NUMBER
DPS1453

WEST VIRGINIA STATE POLICE

SOLICITATION NUMBER: DPS1453
Addendum Number: 7

DPS1453
ADDENDUM NO. 7

First Floor WV State Police 1/8" = 1'

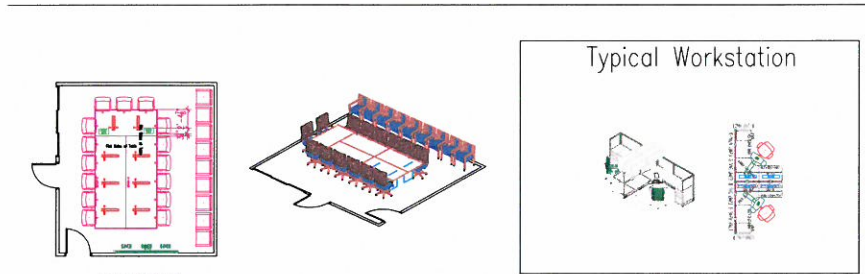
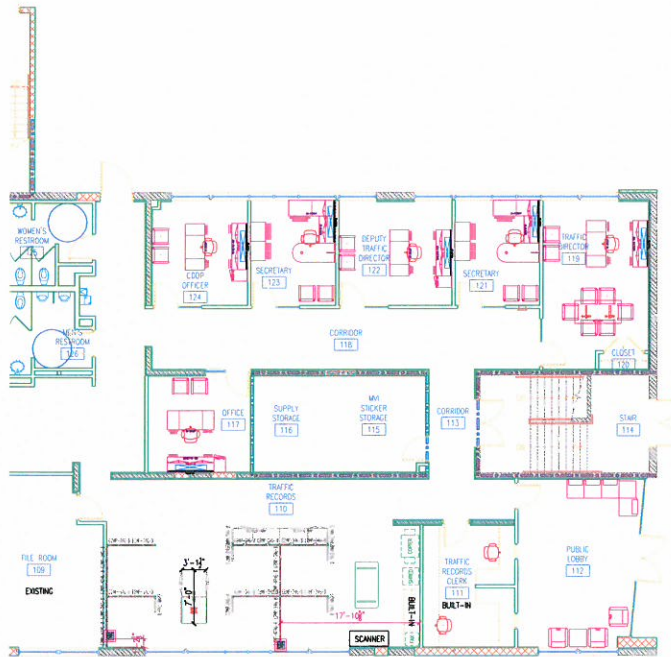
Q1: Panels – In Section 3.3 under general requirements, it states that all panels are to be 62”H. On the drawing, it shows the majority of the modular panels as being 46”H yet in the spec’s it calls for various panels heights. I need clarification for all modular panel heights. Room 203 (all panels are 30” to 46”H). Room 145 (panels are 78”H), Rooms 131, 141, and 143 (on the drawings it shows a height of 46”H. Flippers can’t be hung from panels that are 46”H. Then on the typical workstation it shows the panels with the flippers being higher than the others. Overall I just need clarification of hall modular panel heights. The measurements on the spine of the cubicles cannot be read. Are all of the L-shape stations the same size? We can’t read on the drawing.

Q25: Peds are to be used in the offices (casework) I need to know if they are BBF, FF or BF

A1: See attached drawing is attached of panel sizes only to scale. The majority of the panels are 46” high, there are other height panels, please see drawing to verify. The “hinged door” not flippers are top mount hung not panel hung so they can attach to the 46” high panels. Please see drawing attached for sizes of workstations.

A18: There are no finishes selected as of yet. Please see attached drawing, one BBF in each workstation.

A25: Please see attached drawings for answers on pedestals.

Second Floor WV State Police

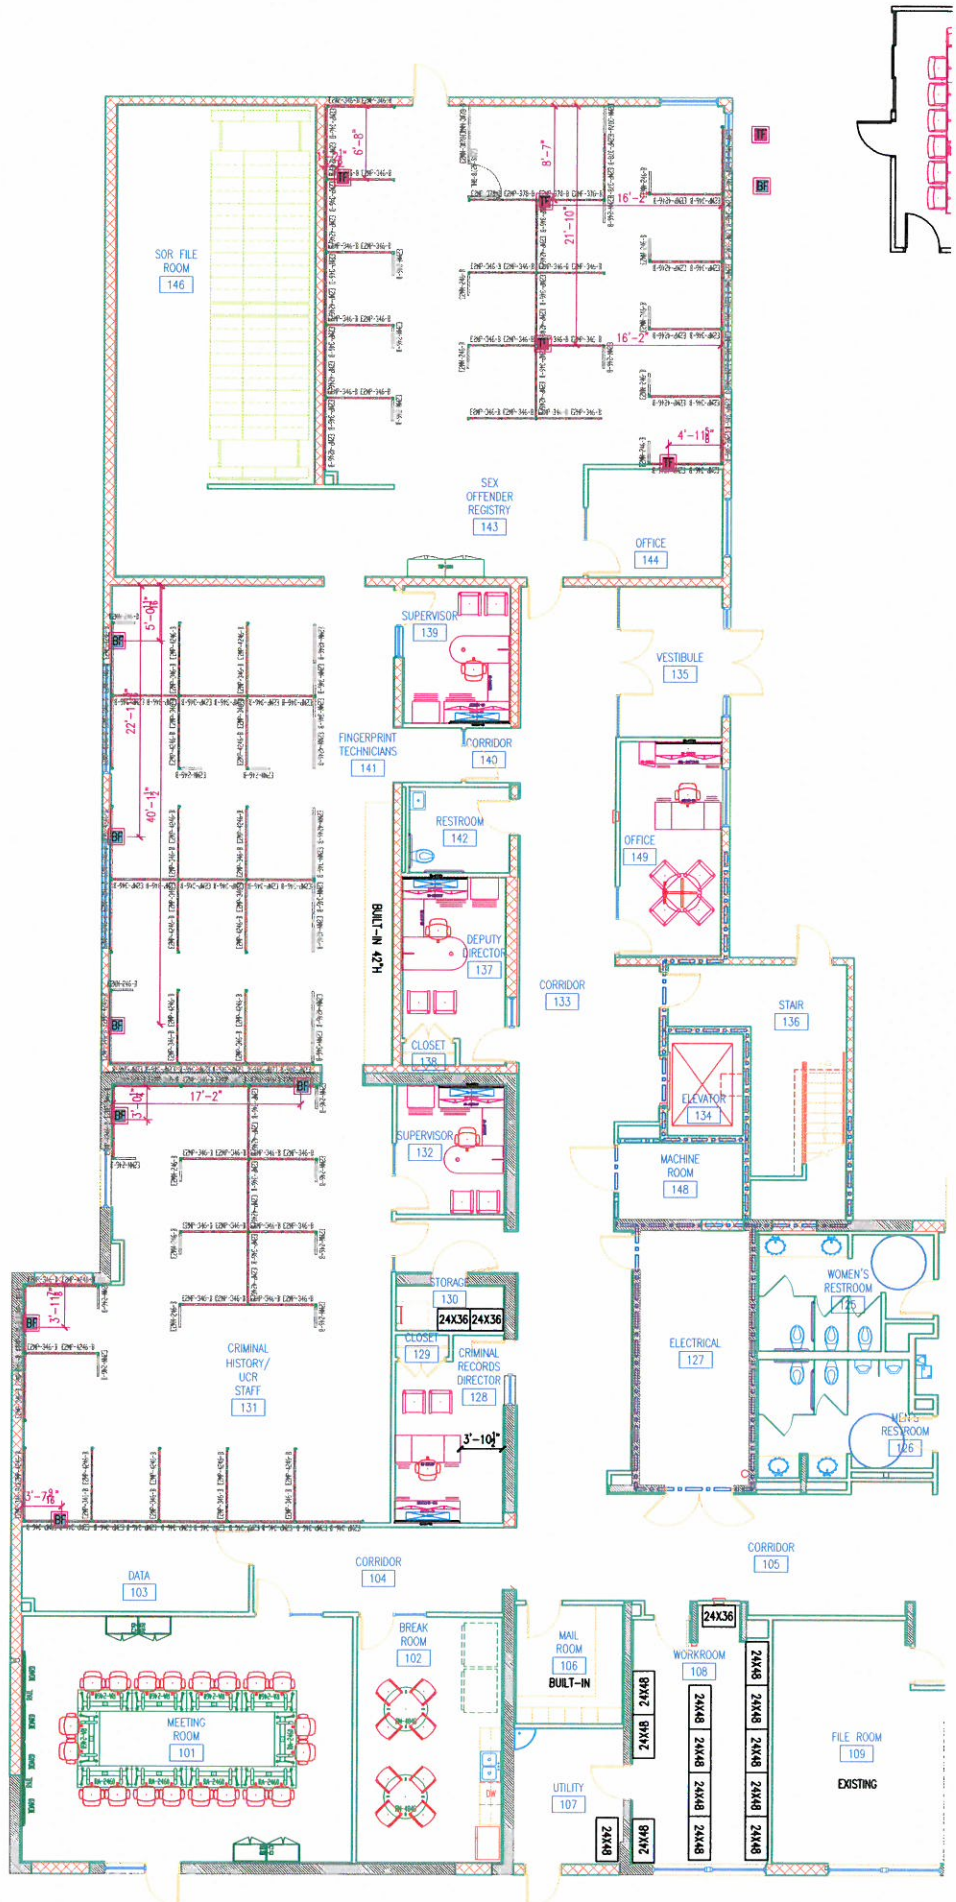
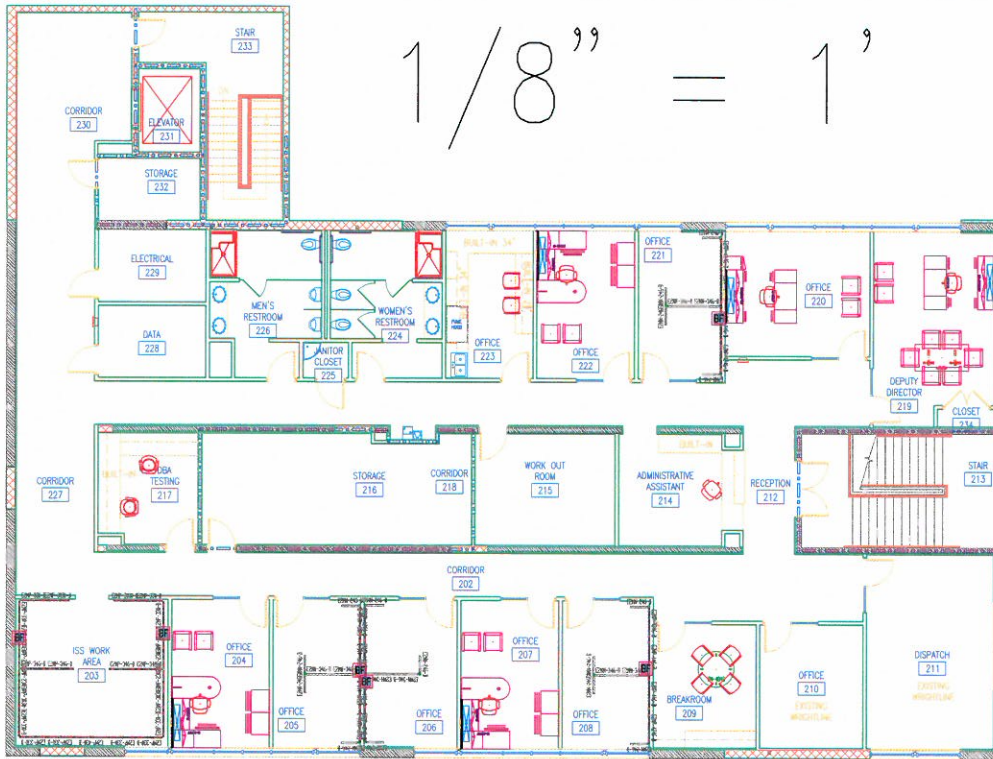
Q28: Room 203 – I need the sizes of the work surfaces and their dimensions to be clarified.

Q34: In room 203, can we make the center station standing height with cantilevers only? What are the work surface dimensions?

A28: See attached drawing for Room 203.

A34: 24" x 24", yes, standing height.
